**Engineering Evaluation/Cost Analysis
Non-Time Critical Removal Action**

**Public Works Transformer Storage Pit and
High Voltage Shop Storage Area**

**Naval Air Weapons Station China Lake,
Ridgecrest, California**

This appendix presents the Navy's responses to comments received from the California Department of Toxic Substances Control (DTSC), the Regional Water Quality Control Board (RWQCB) – Lahontan Region, and the Department of Fish and Game (DFG) (collectively the state) and the Naval Air Weapons Station (NAWS) China Lake Restoration Advisory Board (RAB). State comments were received via letter correspondence from Laurie Racca of the DTSC on September 13, 2007. Attached to the DTSC comment letter, a memo from Victoria Lake of the DFG Office of Spill Prevention and Response dated August 28, 2007 that provided additional comments on the subject report. Additionally, a memorandum from the Ms. Patty Wong-Yim of the DTSC Human and Ecological Risk Division (HERD) was provided with additional comments by HERD and dated August 30, 2007. NAWS China Lake RAB comments were dated September 12, 2007. The state and RAB comments pertain to the following document:

FIGURE 1
SITE LOCATION MAP

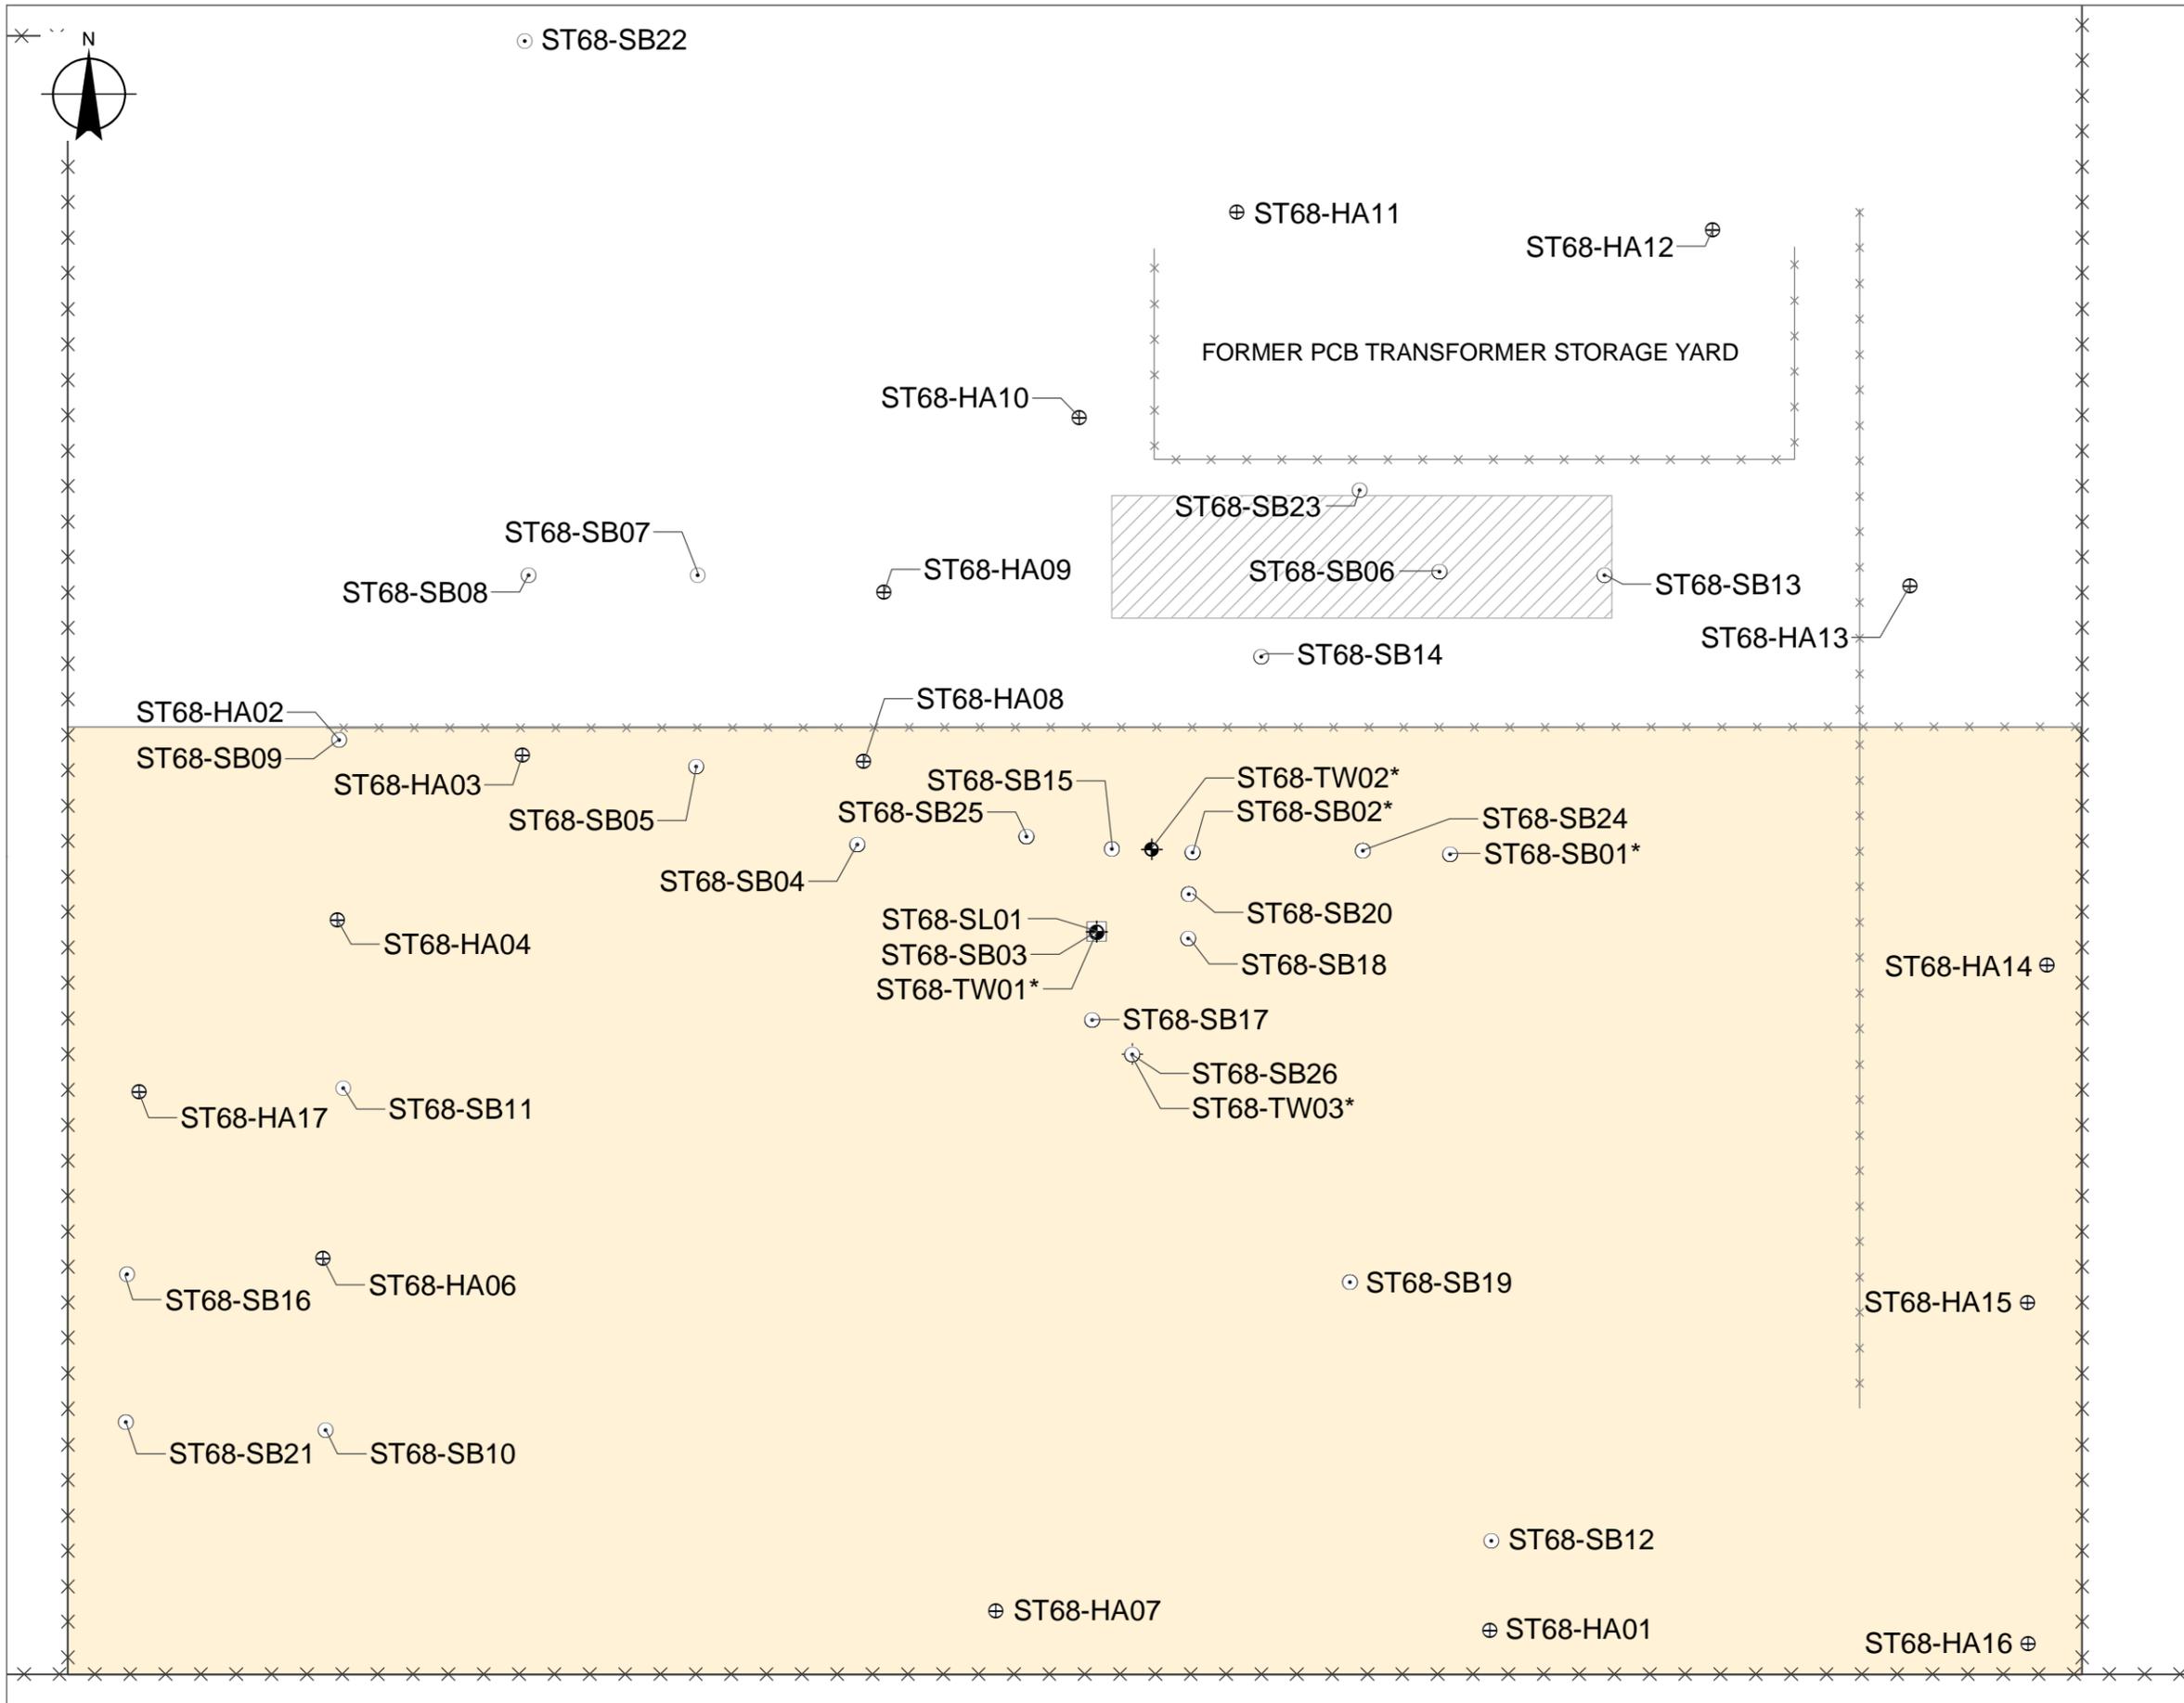
20. **Comment:** Figure 1 **Map shows roads of a past trailer park just south of site. Map does not show new “Business Park” to the west. The Business Park is a “High Density” Area.**

Response: Figure 1 will be revised to show the new business park to the southwest of the PWTSP/HVSSA.

FIGURE 3
HORIZONTAL EXTENT OF PCBs IN SOILS

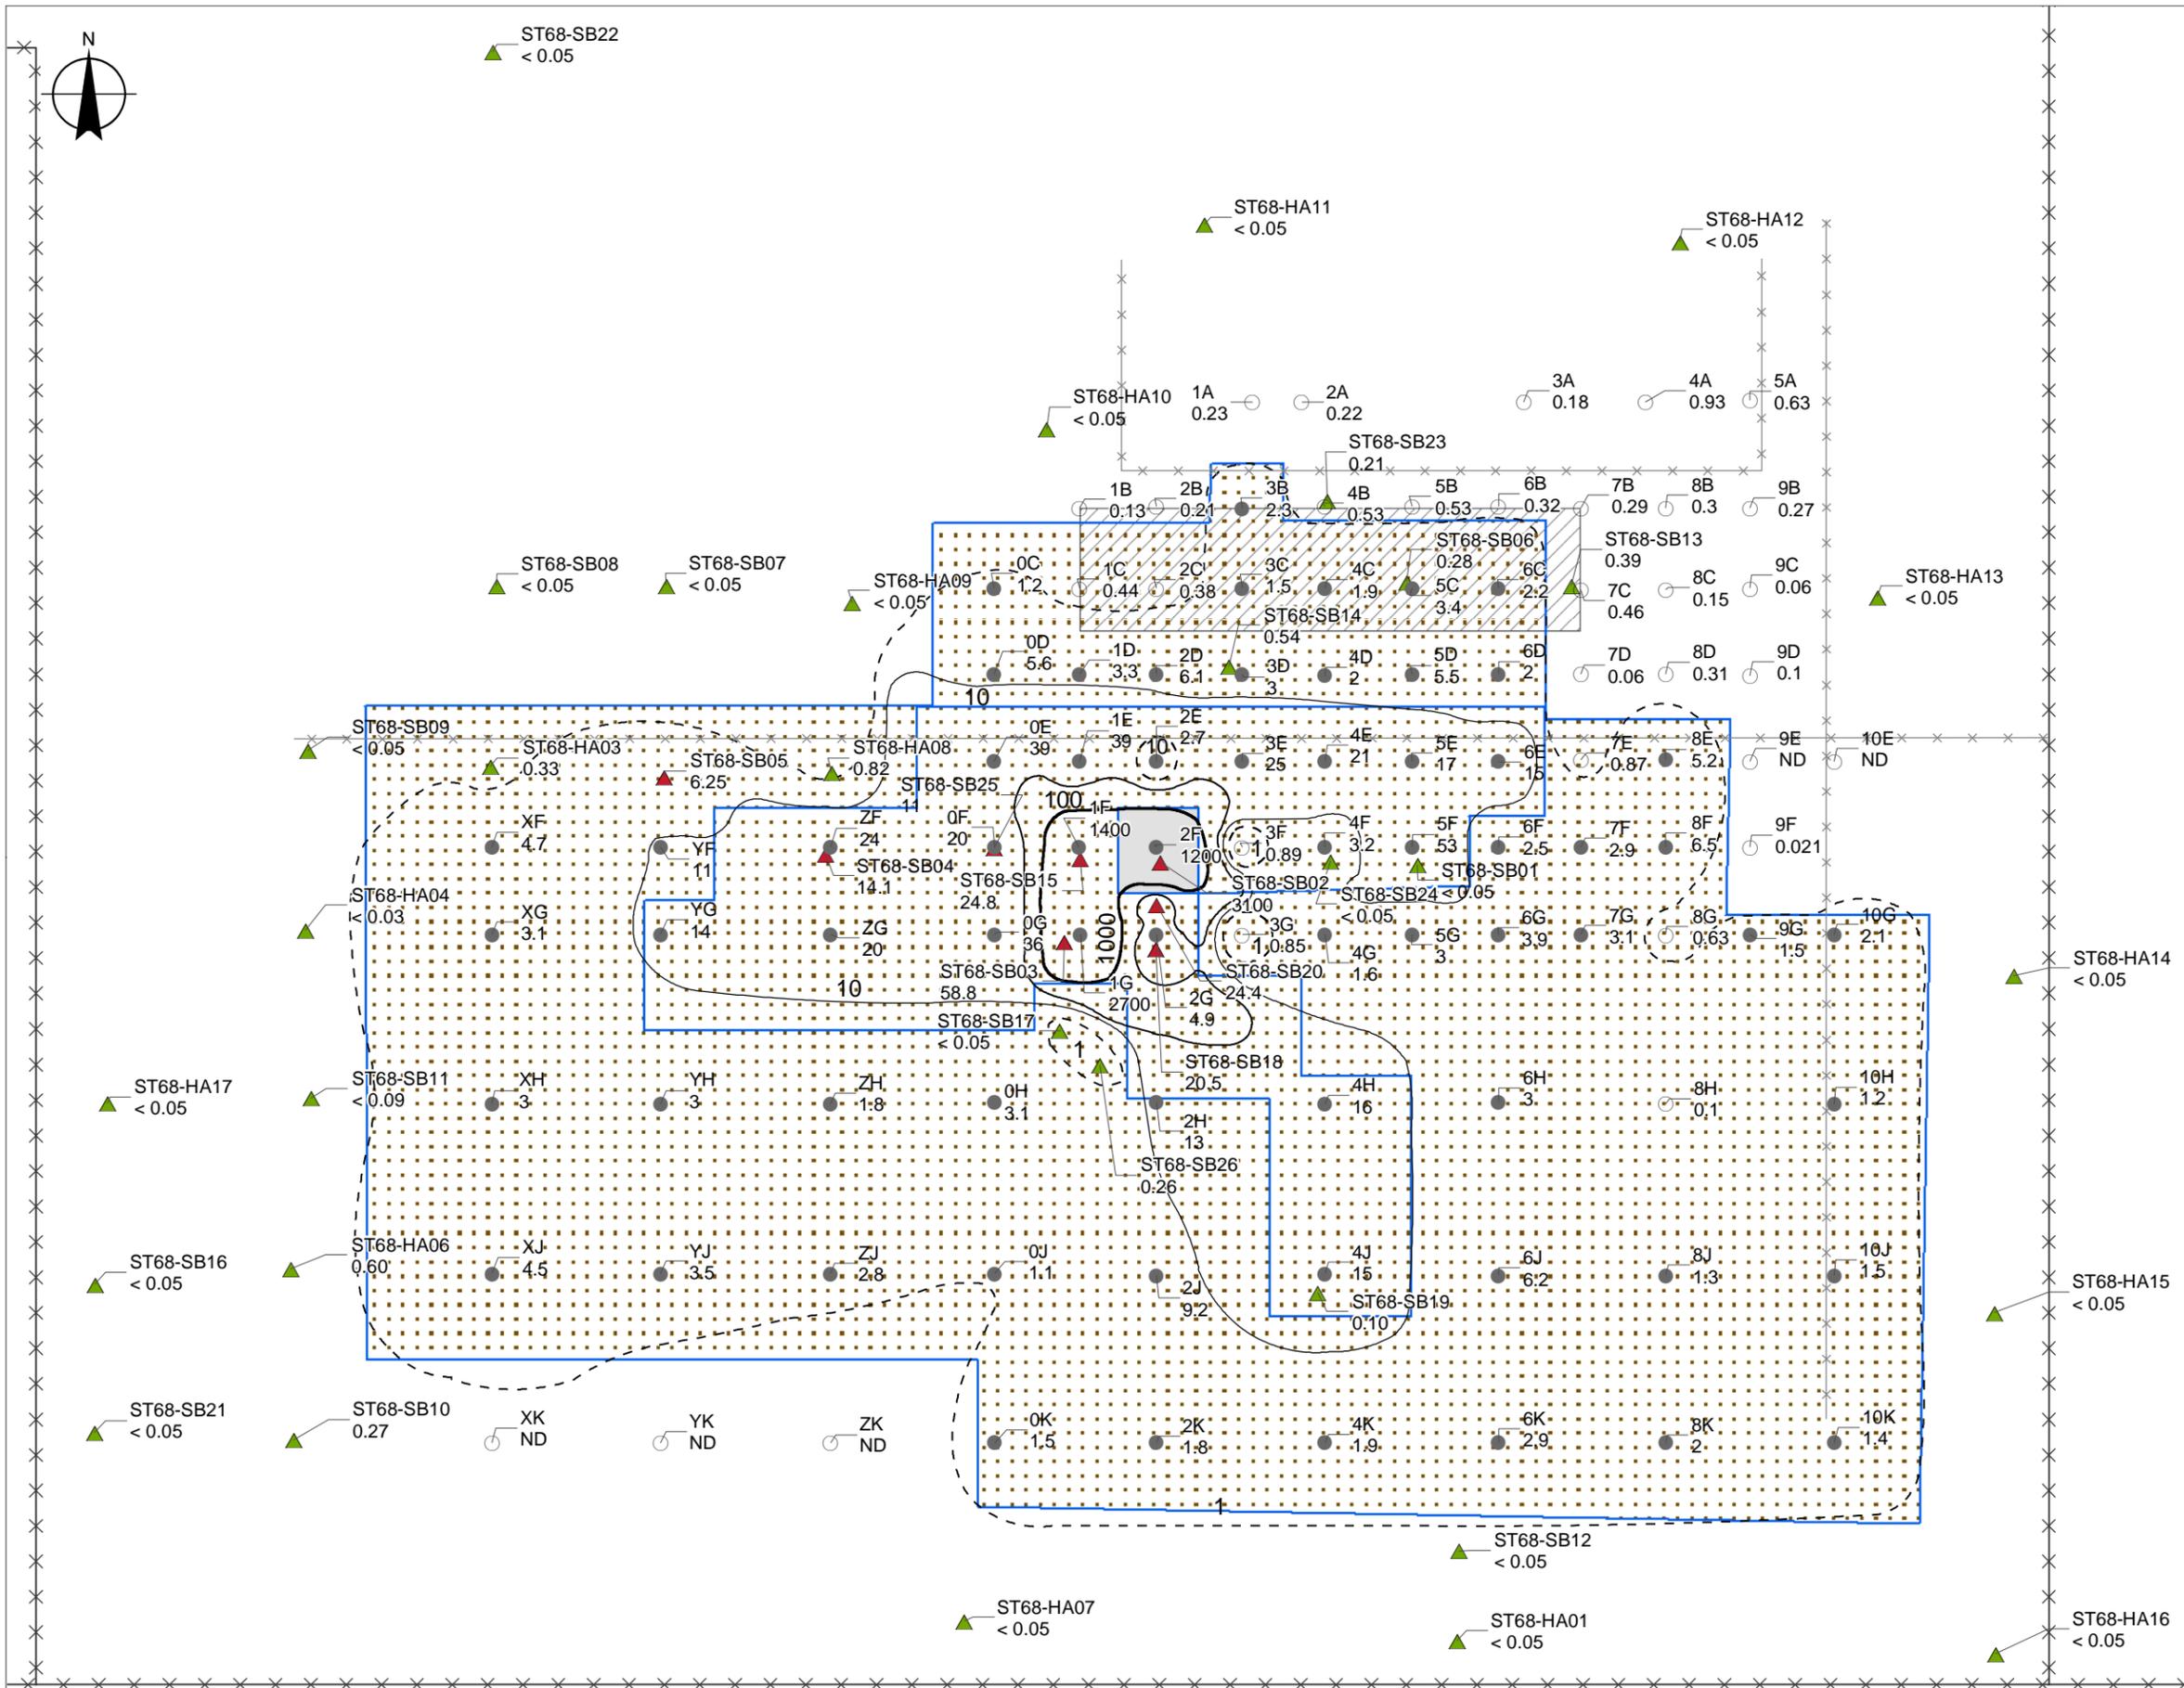
As indicated in Figure 3, these additional soil sampling rounds confirmed that the removal actions in the vicinity of the PWTSP (the “Pit”) had largely removed the PCBs in this area, though minor detections were noted in the area of the PWTSP (generally less than 2 to 3 mg/kg PCBs). However, the presence of elevated concentrations of PCBs in soils was further detected generally south of the PWTSP, resulting in the need for additional removal action.

Response: Due to the volume and differing collection dates of available analytical data, reference to Figure 3 is considered to be the most efficient method of conveying analytical results of soil sampling.
